Access Compliance Report

Public Rights-of-Way

Intersection ID: 10026140	Main Street: ERWIN_RD	Cross Street: N/A	Location: W
ADA ID: 21565F9FB7D0	Ramp Type: Perp	Initial Pass/Fail: Fail	Overall Compliance: No
Severity Score: 8.75			
Codes/Mitigation Info/Possible Solution		Field Measurements/Component Compliance

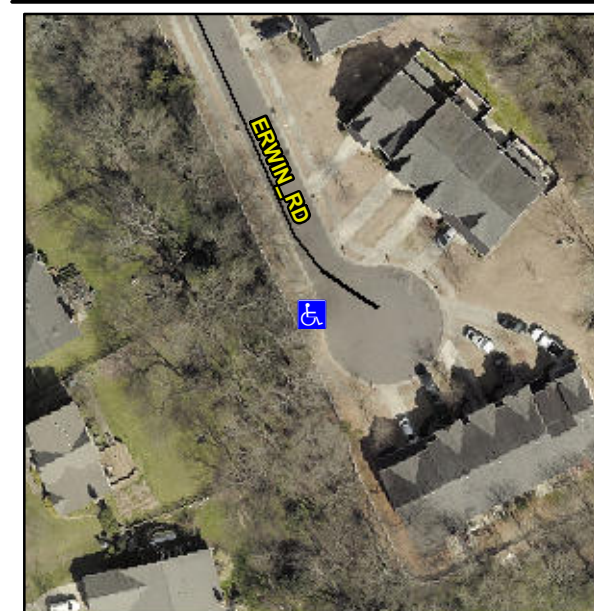
Not Found, R304.5.1

Compliance	Description	Data	Compliance	Description	Data
N/A	Ramp Length (in)	36.0	Yes	Ramp Slope (%)	5.1
No	Ramp Width (in)	44.0	Yes	Ramp XSlope (%)	0.9
N/A	Flare Type LT	N/A	N/A	Flare Type RT	N/A
N/A	Flare Slope LT (%)	N/A	N/A	Flare Slope RT (%)	N/A
N/A	Flare Traversable LT?	N/A	N/A	Flare Traversable RT?	N/A
N/A	Landing Length (in)	N/A	N/A	DWS Provided?	N/A
N/A	Landing Width (in)	N/A	N/A	DWS Contrast?	N/A
N/A	Landing Slope (%)	N/A	N/A	DWS Length (in)	N/A
N/A	Landing X Slope (%)	N/A	N/A	DWS Full Width?	N/A
N/A	Landing Curb? (Y/N)	N/A	N/A	DWS Offset (in)	N/A
N/A	Shared Landing?	N/A			
N/A	Gutter Ponding?	N/A	N/A	Gutter Slope (%)	N/A
N/A	Gutter Lip Ht (in)	N/A	N/A	Gutter X Slope (%)	N/A
N/A	Painted X Walk1?	No	N/A	Painted X Walk2?	N/A
	X Walk 1 Direction	To E		X Walk 2 Direction	N/A
N/A	X Walk 1 Width (in)	N/A	N/A	X Walk 2 Width (in)	N/A
	X Walk 1 Slope (%)	3.6		X Walk 2 Slope (%)	N/A
	X Walk 1 X Slope (%)	1.4		X Walk 2 X Slope (%)	N/A

Remove & Replace Entire Ramp.
